STAFF REPORT 03-16-2022 SPECIAL MEETING

APPLICATION NUMBER: 22-7701

ADDRESS: 6125 14TH STREET (AKA KING SOLOMON BAPTIST CHURCH)

SCOPE: ALTER AND REPAIR PORTIONS OF ROOF; STABILIZE MASONRY

Bell Tower Roof Demo Plan

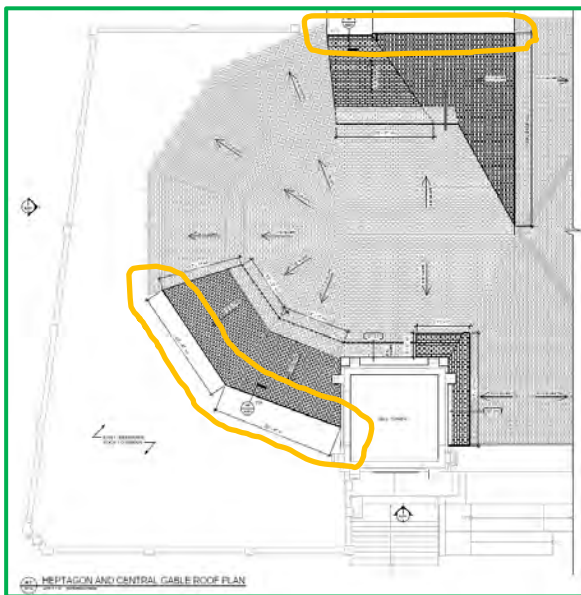
Note difference in depth of roof eaves between existing (demo) and proposed.
